# 752 MARINE DRIVE

## DEVELOPMENT PERMIT APPLICATION RESPONSE TO DRC COMMENTS

JANUARY 2015

## 2.1 HEIGHT AND RELATIONSHIP TO MARINE DRIVE

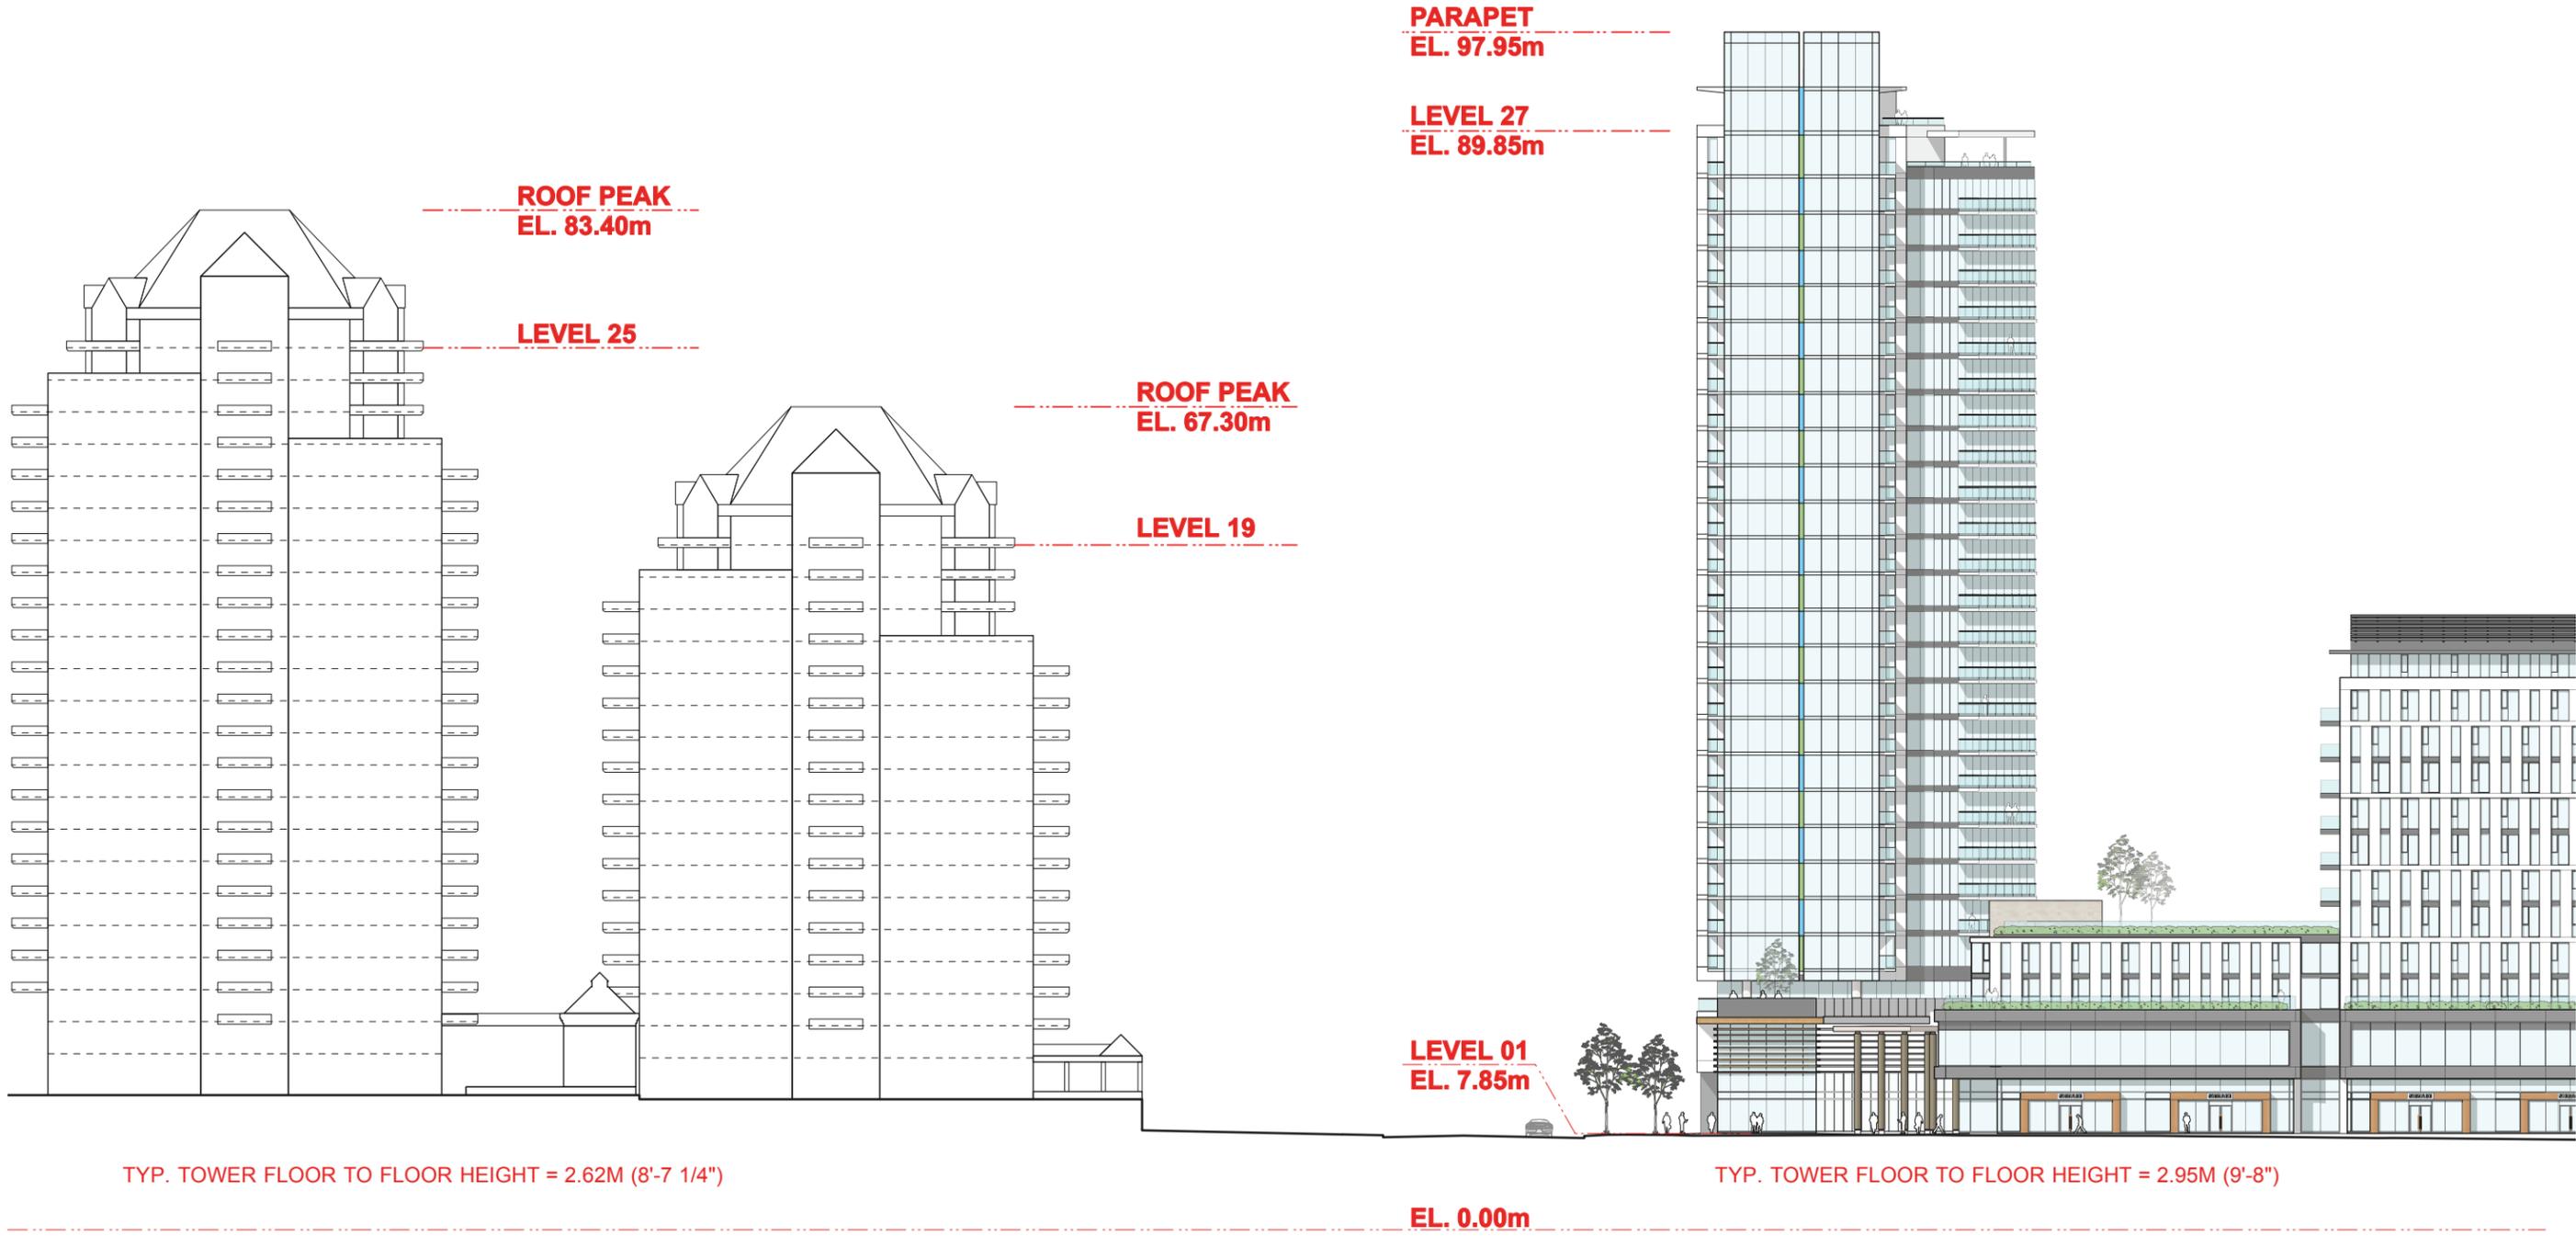
- **Height and Relationship to Marine Drive** To improve the relationship of the building mass to Marine Drive, the height of the west tower has been reduced from 15 storeys to 12 storeys. To offset the loss in density caused by this height reduction, the west tower has been extended further to the west and another level has been added to both the podium (now 4 storeys) and the east tower (now 27 storeys).

The Marine Drive elevation has also been modified to clearly define and give greater transparency to the office component. At street level, greater variety has been introduced in the form of smaller storefronts defined by “wood” portals.

At the intersection of Marine and Taylor, a new water feature marks the entrance to Park Royal. At the west end of the west tower, a large canopy has been added to provide weather protection and improve the pedestrian scale. The entrance to the residential lobby of the west tower has also been moved further west to improve its proximity to the drop-off.

**HEIGHT OF WEST TOWER REDUCED BY 3 STOREYS**

To off-set the loss of density caused by this reduction in height, the west tower (now 12 storeys) has been extended further to the west and another level has been added to both the podium (now 4 storeys) and the east tower (now 27 storeys)

**GREATER TRANSPARENCY IN OFFICE PODIUM**

**NEW WATER FEATURE TO MARK THE ENTRANCE TO PARK ROYAL**

**IMPROVED RETAIL FRONTAGES INCLUDING THE ADDITION OF MORE WOOD LIKE ELEMENTS**

**NEW CANOPY TO PROVIDE ADDITIONAL WEATHER PROTECTION AND IMPROVE PEDESTRIAN SCALE AT STREET LEVEL**

**LARGER OPENINGS TO ALLOW RETAIL ACTIVITY TO SPILL OUT ONTO STREET**

**ENTRANCE TO RESIDENTIAL LOBBY MOVED FURTHER WEST TO IMPROVE PROXIMITY TO DROP-OFF**

**EXPOSED COLUMNS AT STREET LEVEL TO IMPROVE SCALE AND ARCHITECTURAL RHYTHM**

2.2 HEIGHT COMPARISON TO WEST ROYAL TOWERS

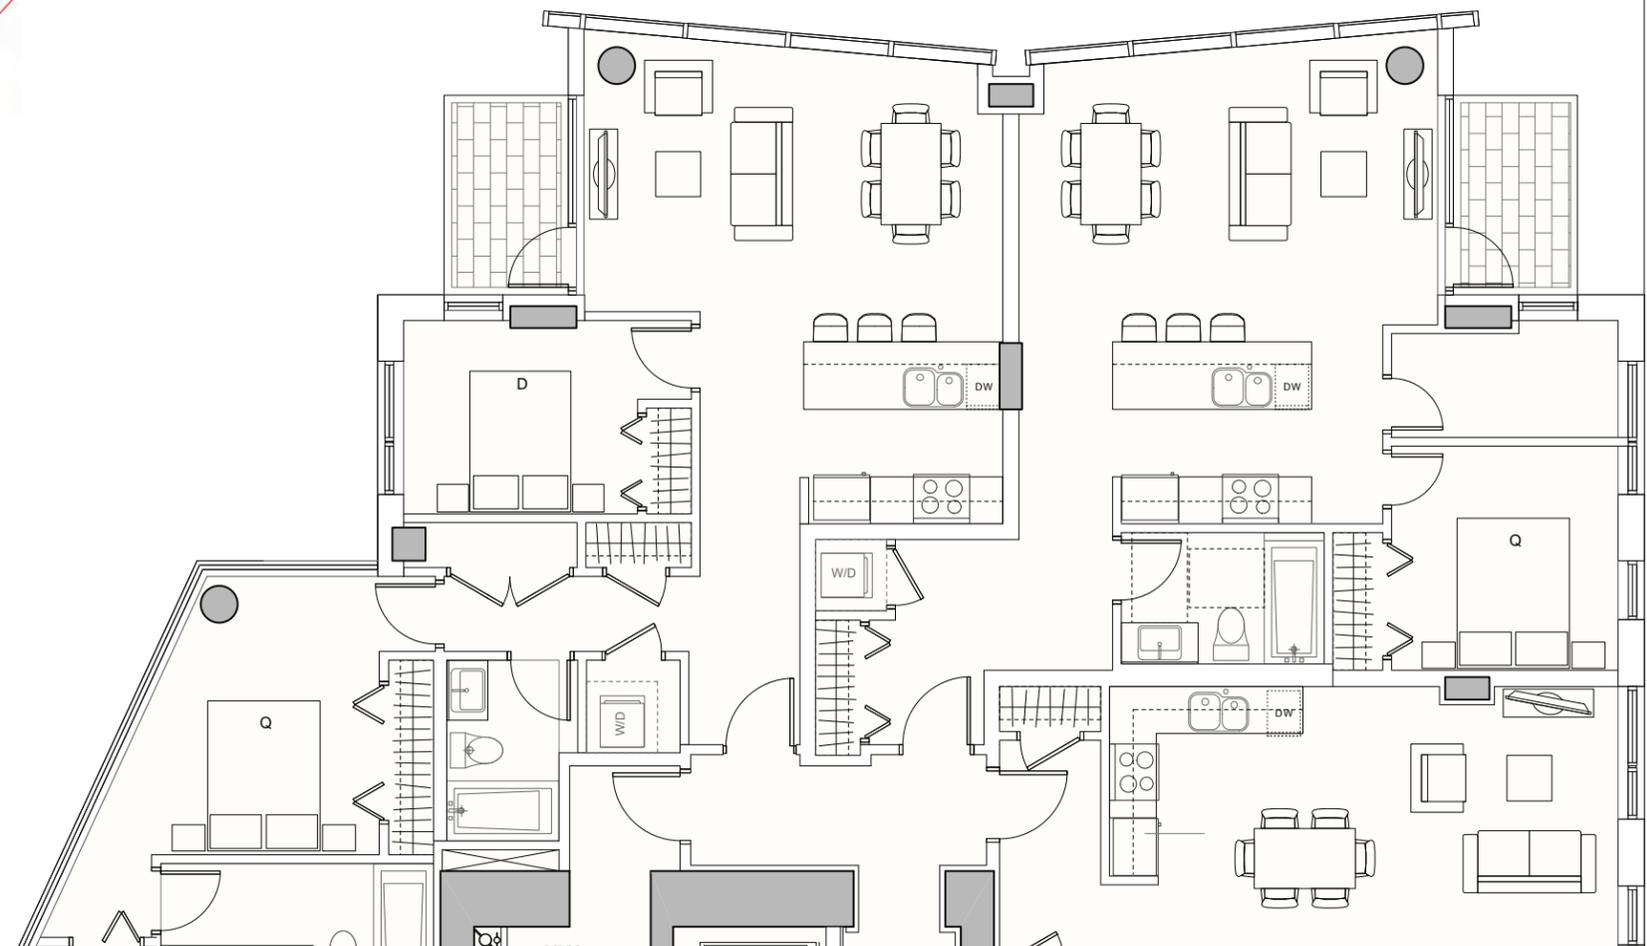
- **Height Comparison with West Royal Towers** The height of the project relative to the adjacent West Royal Towers has been illustrated.
- **East Tower Curtainwall** The north curtainwall of the east tower has been modified to provide greater visual interest and a more iconic expression. Panes of glass have been slightly angled and a reveal has been created down the middle. This reveal will have alternating coloured panels and could potentially be illuminated at night.

**THE NORTH CURTAINWALL HAS BEEN MODIFIED TO PROVIDE GREATER VISUAL INTEREST. PLANES OF GLASS HAVE BEEN ANGLED AND A REVEAL HAS BEEN CREATED DOWN THE MIDDLE. THIS REVEAL WILL HAVE ALTERNATING COLOURED PANELS AND COULD POTENTIALLY BE ILLUMINATED AT NIGHT.**

## 2.4 SOUTH FACADE

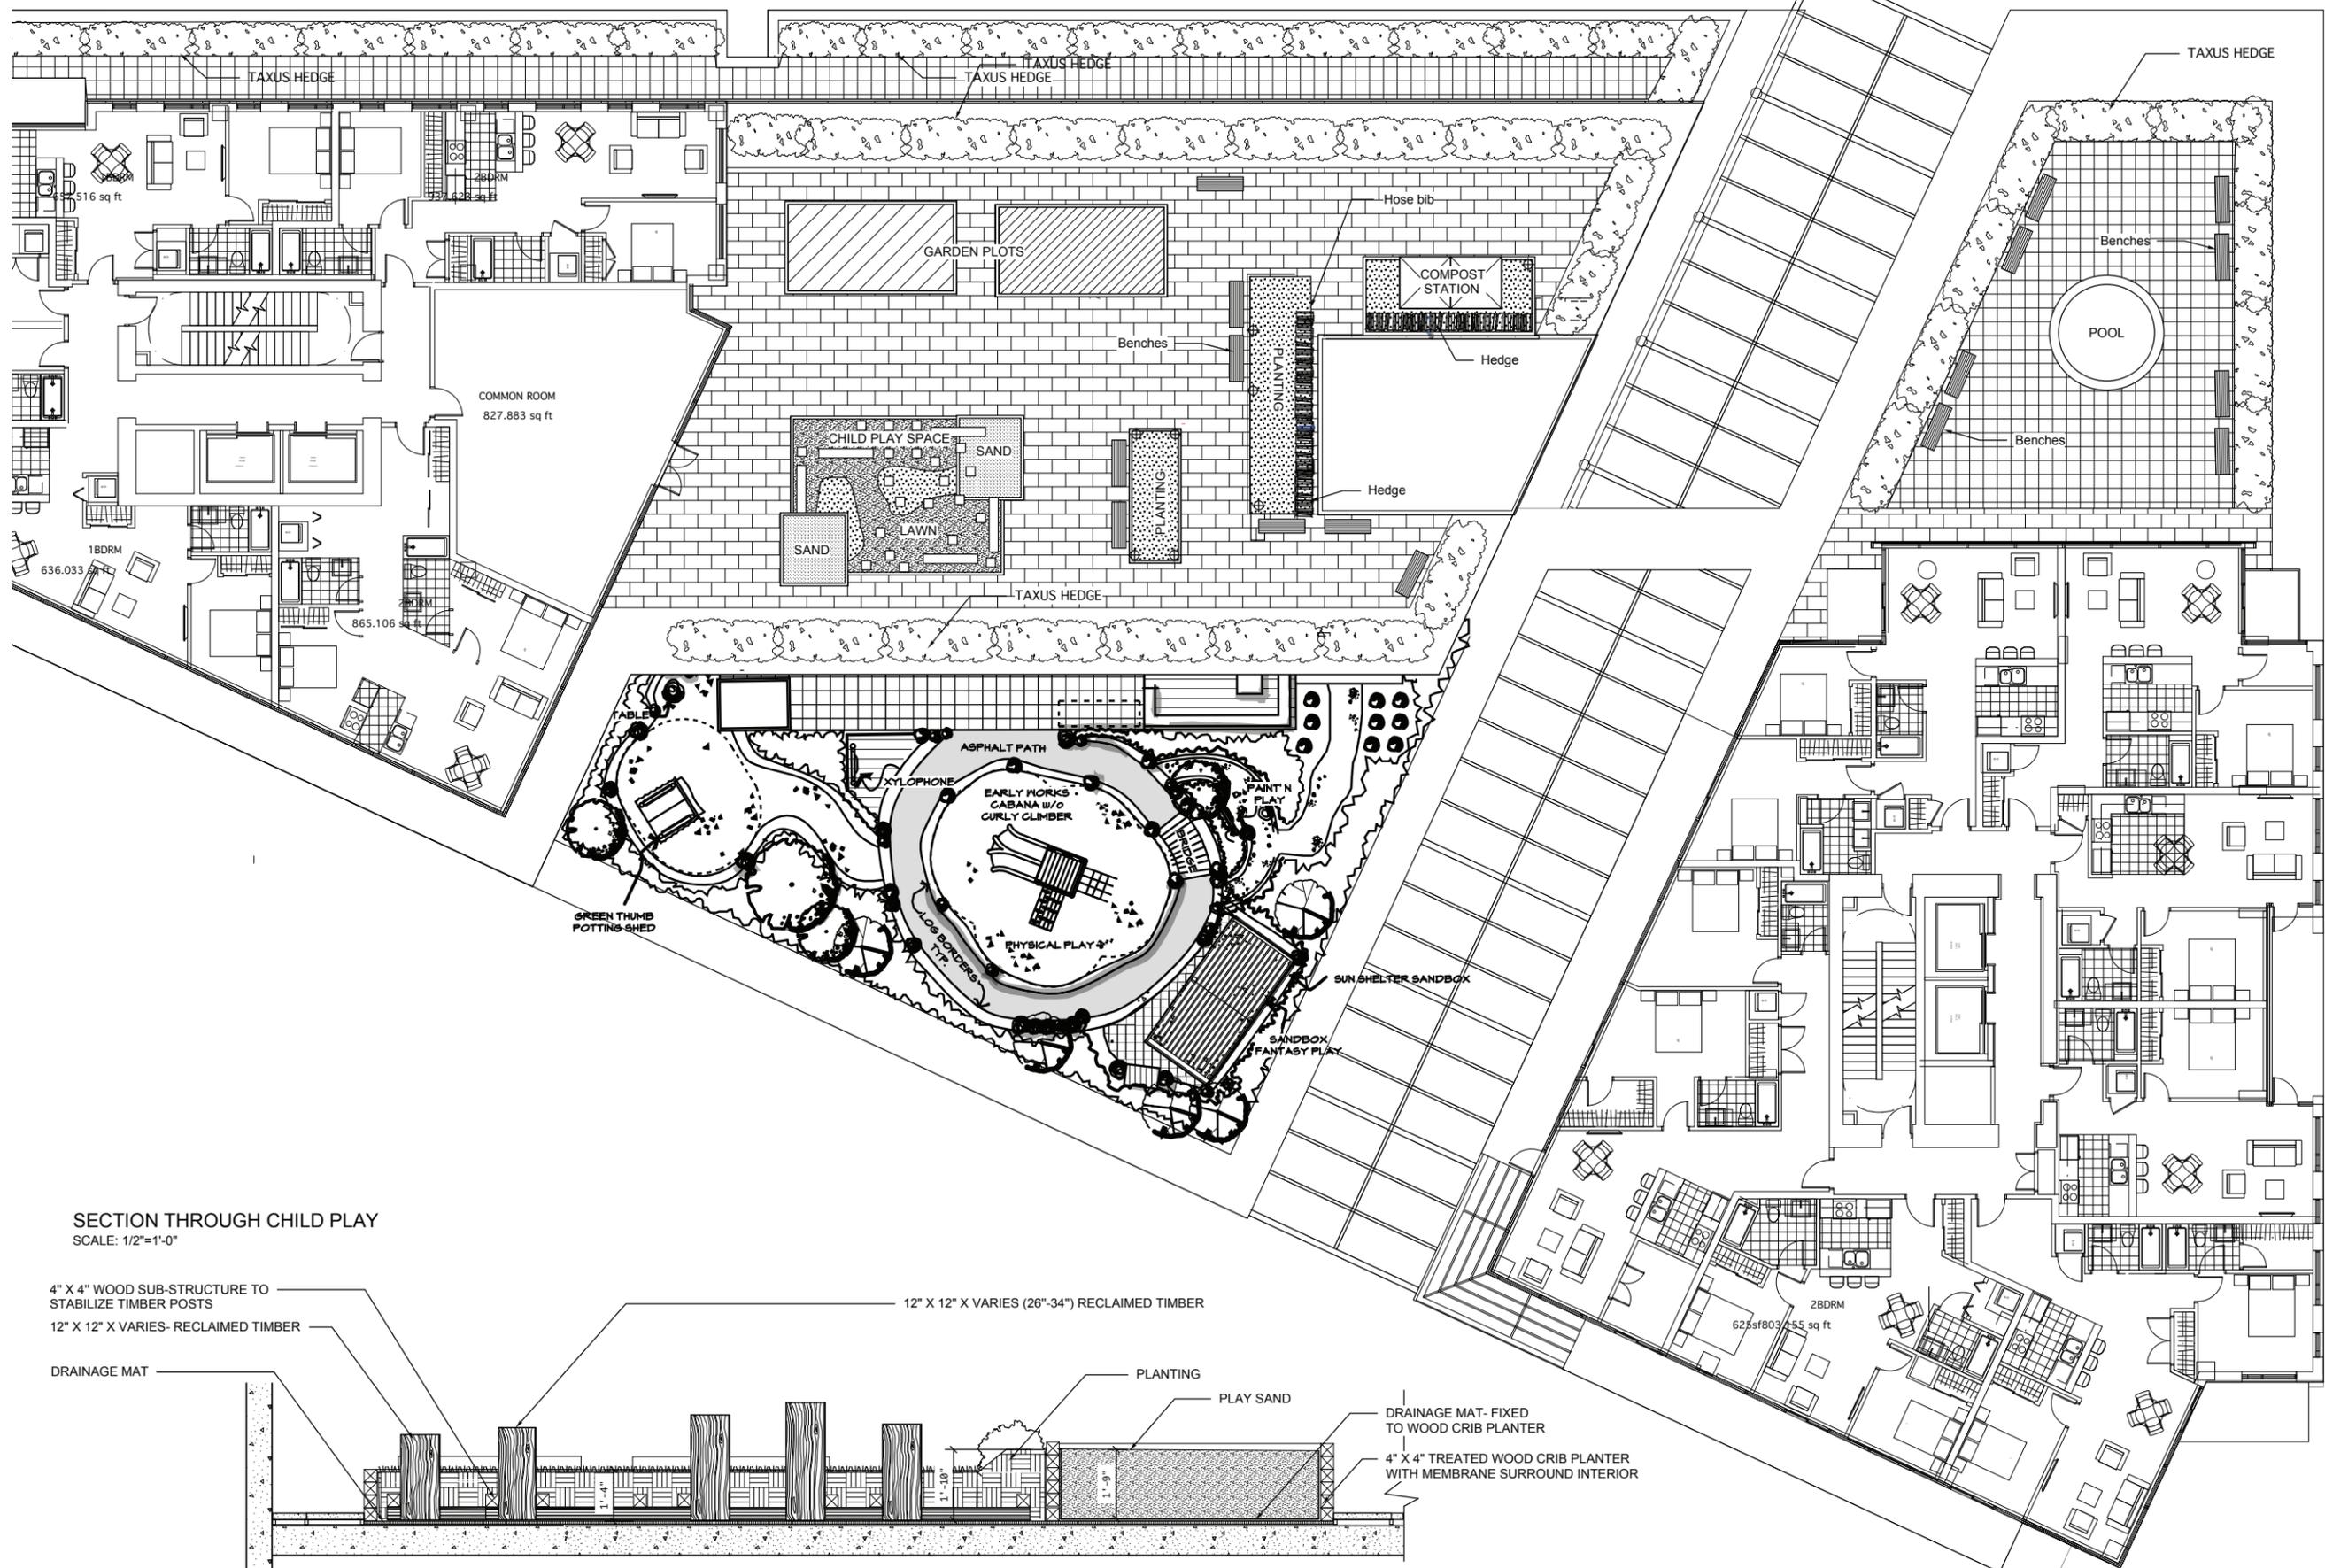
- **Retail Galleria** The retail galleria has been modified to include more storefront locations. Overhead doors have been included to allow retail activity to potentially spill out into the galleria. Banners and additional seating elements have also been included.

- **South Facades** The south façades have been modified to provide greater visual interest and improved thermal performance. This is in the form of an alternating rhythm of insulated spandrel panels.

**MORE OPACITY TO IMPROVE THERMAL PERFORMANCE AND CREATE MORE VISUAL INTEREST. THIS INCLUDES AN ALTERNATING RHYTHM OF SPANDREL AND VISION GLASS.**

**GLAZED CANOPY TO PROVIDE WEATHER PROTECTION**

**BANNERS TO PROVIDE GREATER ANIMATION**

**ENTRANCE TO OFFICE LOBBY MORE CLEARLY INDICATED**

**OVERHEAD DOORS ALLOW ACTIVITY TO SPILL OUT INTO GALLERIA**

**ADDITIONAL ENTRIES PROVIDED ALONG RETAIL GALLERIA FOR GREATER ANIMATION**
